Subject: Finding of No Significant Impact (FONSI)
Mauumae Nature Park Master Plan, Tax Map Key 3-3-014: 015, and 017
Honolulu, Oahu, Hawaii

MAU'UMAE NATURE PARK MASTER PLAN
Honolulu, Oahu, Hawaii

Draft Environmental Assessment Report for the
Mau'umae Nature Park Master Plan
TMK: 3-3-014: 015 and 017 in Palolo, Oahu, Hawaii

Figure 1
Location Map
Mau'umae Nature Park

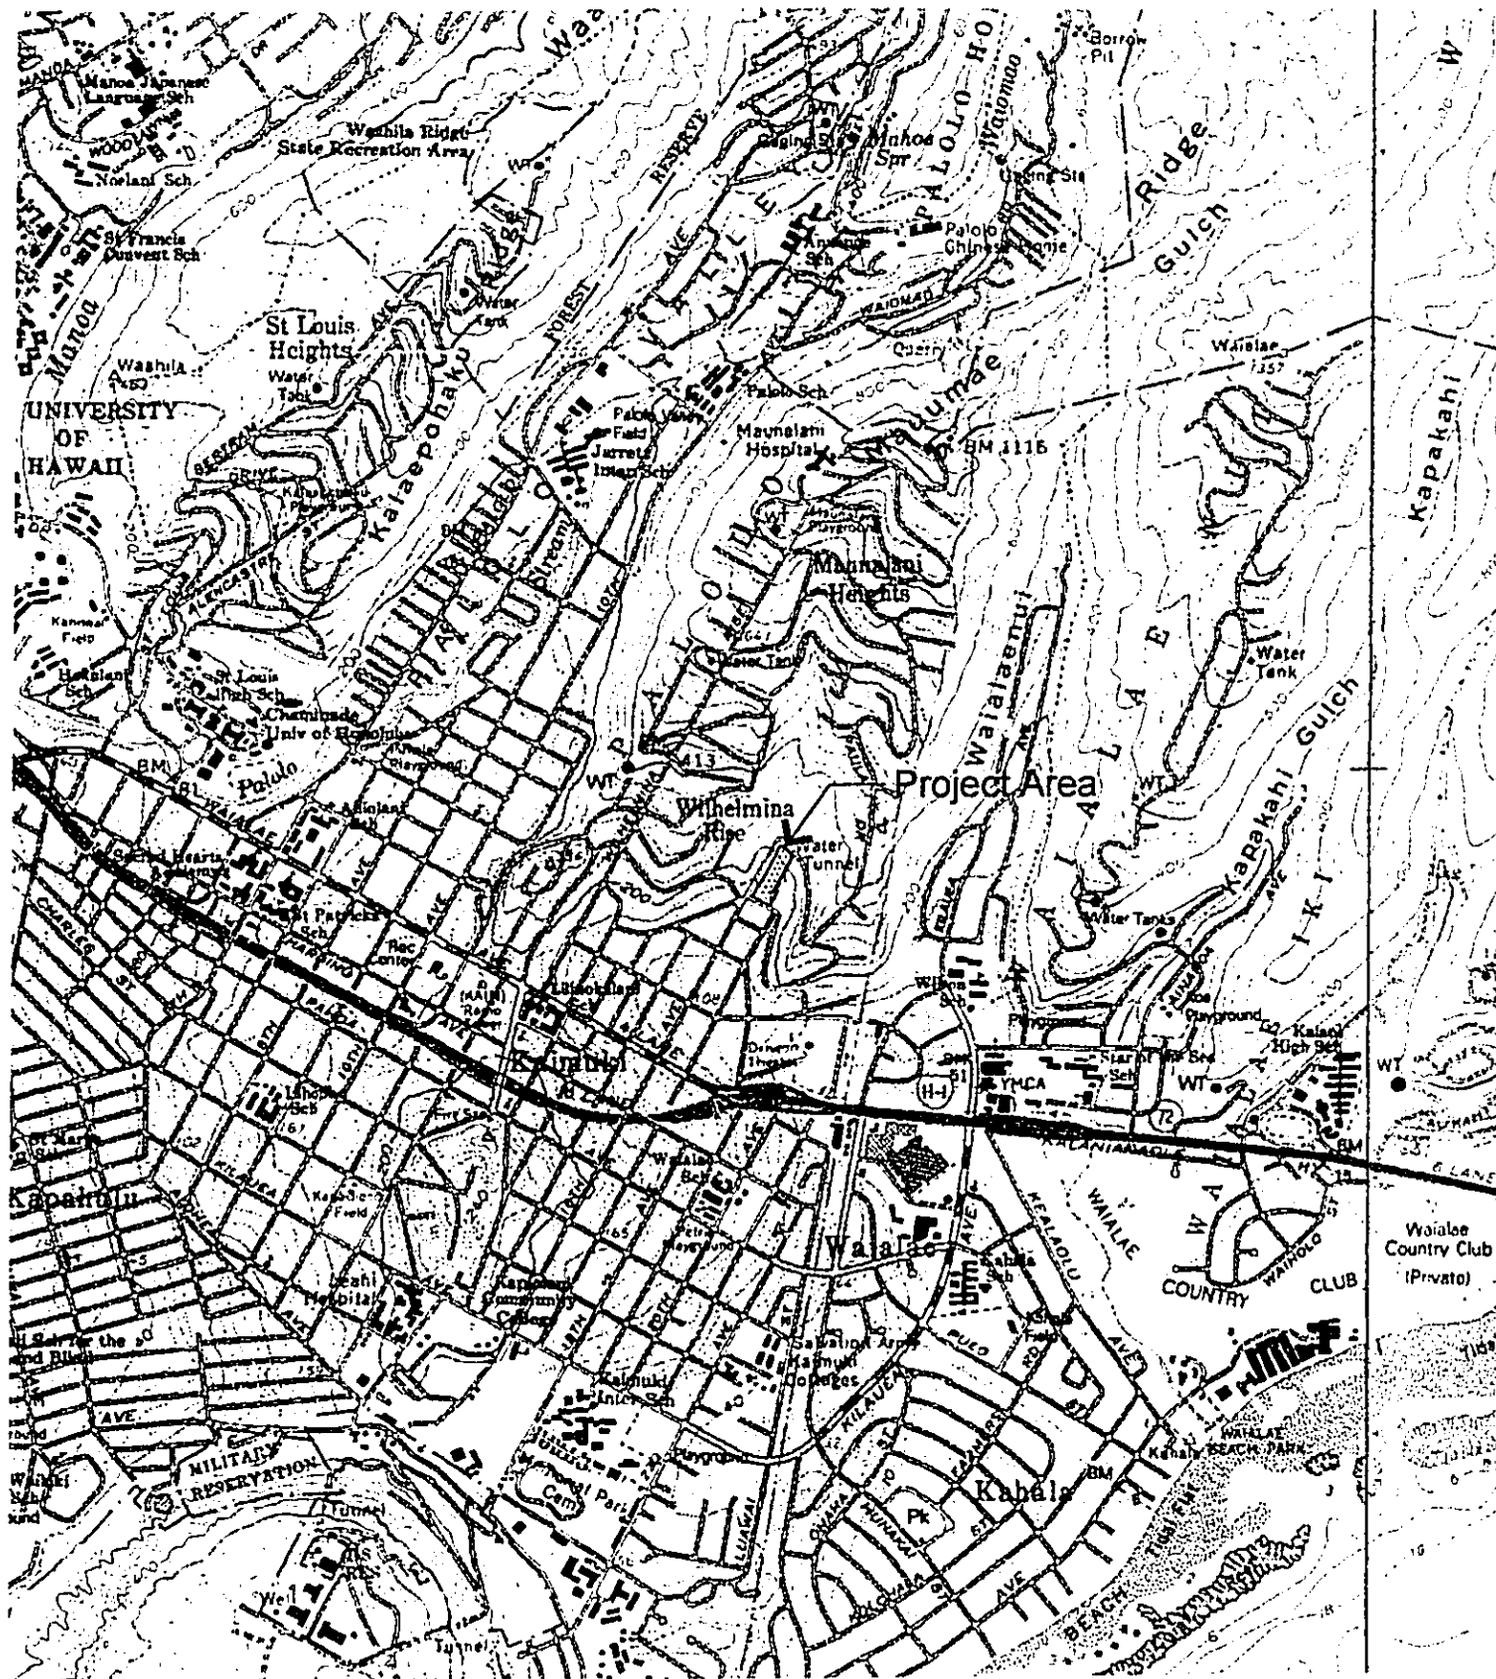
- First, paragraph 2, of page 1, Description of the Proposed Project does not include TMK parcel (3-3-019) and the Nature Park is 33 acres in size, not 3.9 acres.
- Second, paragraph 6 of page 2 should be revised to reflect that TMK parcel 3-3-019 will also remain undeveloped except for a hiking trail.
- Third, revise the project area outlined on the Figure 1 Location Map to reflect the actual size of the Nature Park.

- 1. TMK 3-3-019 was not included in the contract documents for preparing the Maunuae Nature Park Master Plan. The Nature Park is 33 acres in area; however, the Master Plan was prepared only for the parkland below Koko Drive, which is 3.9 acres.
- The text of paragraph 2 will be revised to indicate that TMK: 3-3-019: 005 although part of the Nature Park is not included in the Master Plan.
- 2. The text of paragraph 6, page 2 will be revised to indicate that TMK parcel 3-3-010 will remain undeveloped except for a hiking trail.
- 3. The Location Map (Figure 1) must be left as is to reflect the 3.9 acre Master Plan area within the project and EA scope.

Figure 3
Site Plan
Mau'umae Nature Park

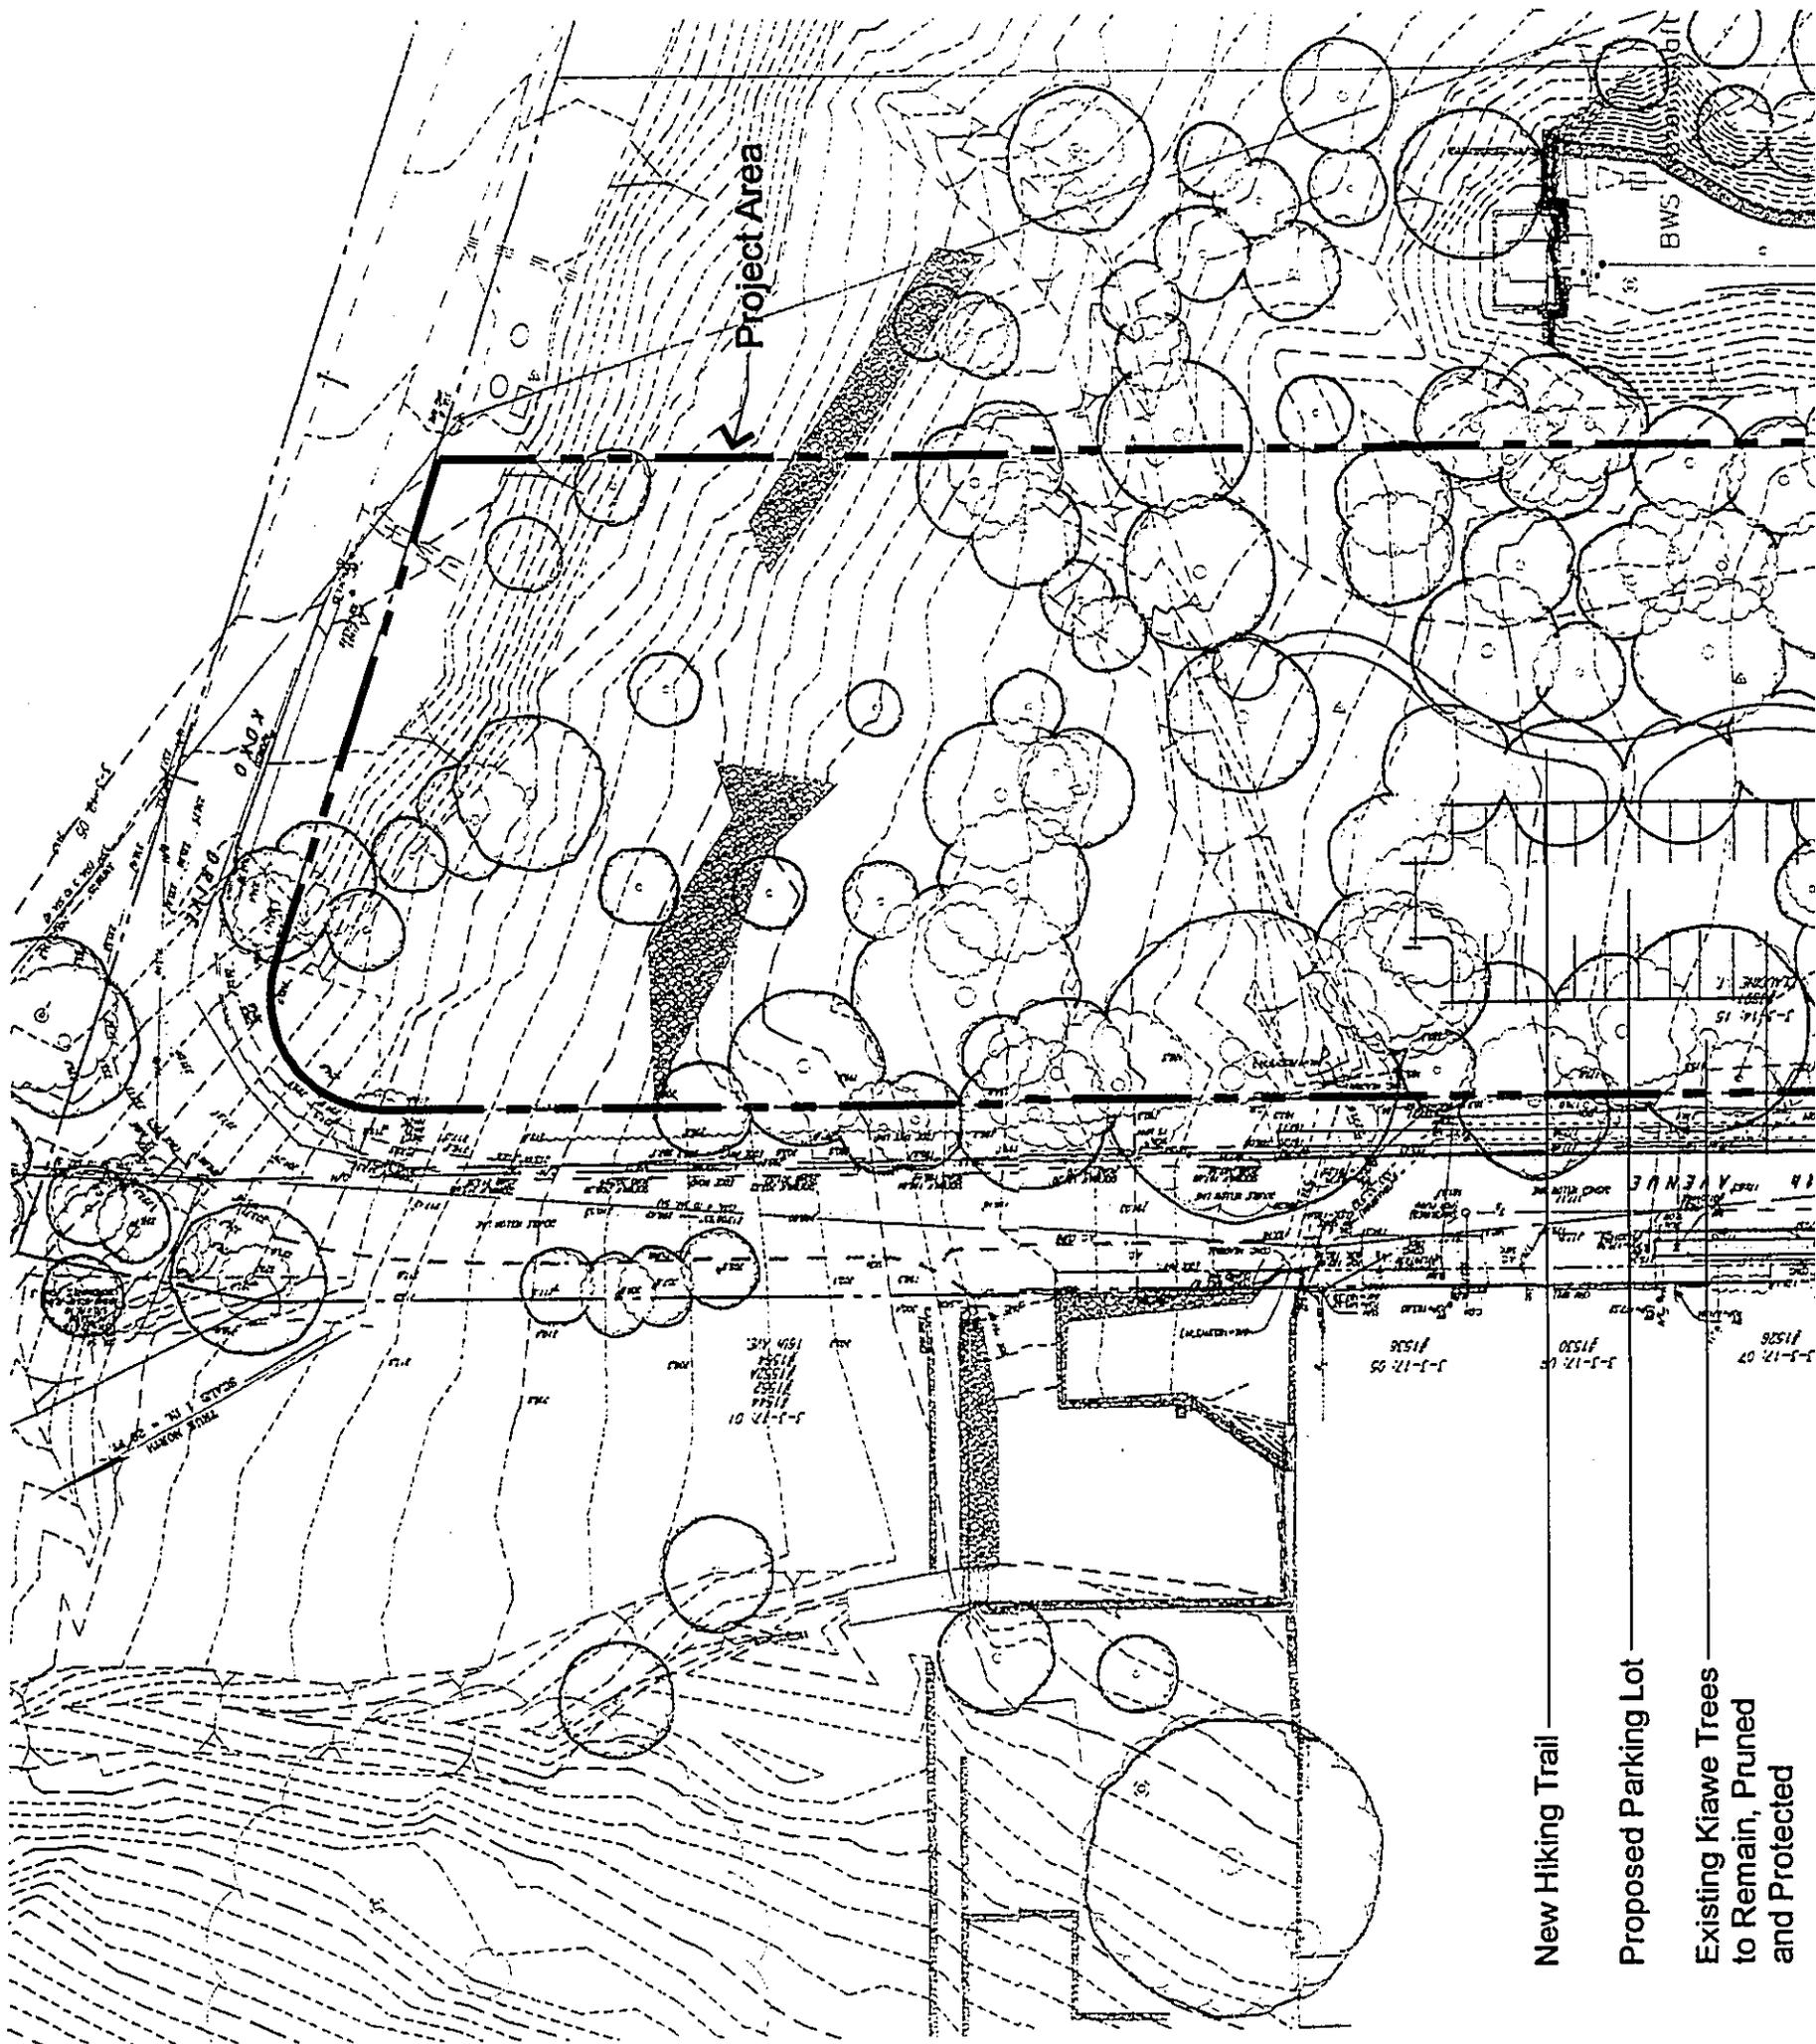
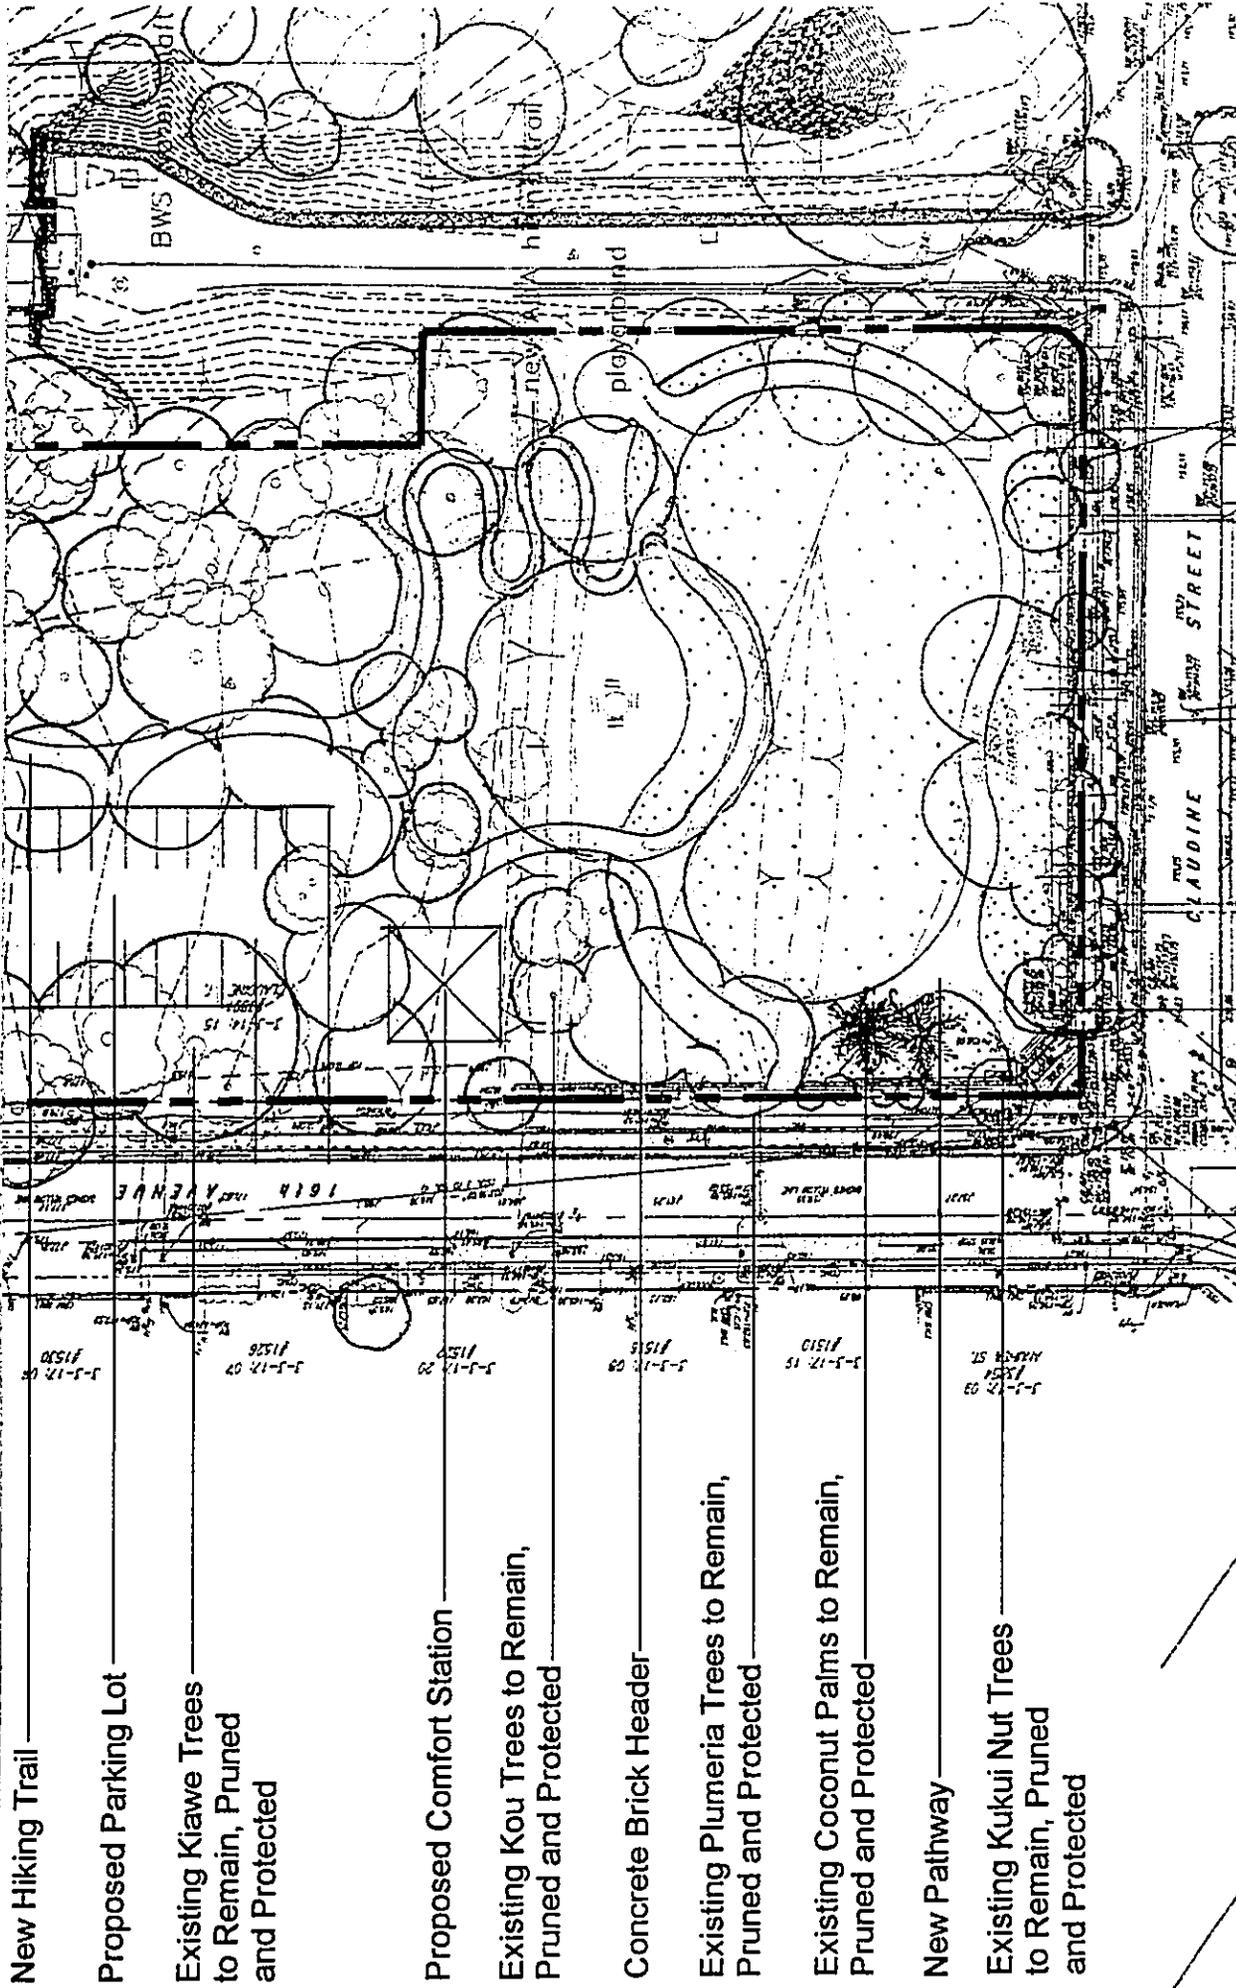
1. Pages 1 (Section 1.B), 6 (Figure 3), 7 (Section 2.A) and 19 (Section 3.B): The
DEA states that the proposed improvements would not displace any existing
recreational activity (page 19). However, Section 2.A on page 7 states that
"children and youth groups use the grass field for organized recreation (practice
purposes) and open space play." The FEA should be more specific in discussing
the open area (include dimensions and square footage), which will be created by
the walkway (page 1) and the long-term impacts on the current recreational
activities. Will the open lawn area created by the new walkway accommodate the
children and youth groups currently using the existing lawn area for organized
recreation and open space play?

2. Page 3, Section 1. D. Social Characteristics: The FEA should include the positive
social benefits resulting from the proposed recreational area.
3. Page 6, Figure 3: The two shaded areas in the upper or northern portion of the
park should be identified.

The proposed improvements would not displace any recreation activity now occurring on the premises. The addition of meandering walkways would provide a safe place for children to ride their bikes and tricycles and the play structure would provide a recreation feature. The short hiking trail may encourage people to explore the hillside vegetation and landform.

The parking lot and the comfort station would provide permanent facilities for park users. Currently park users park on the neighboring streets and the only restroom facility is a portable toilet.
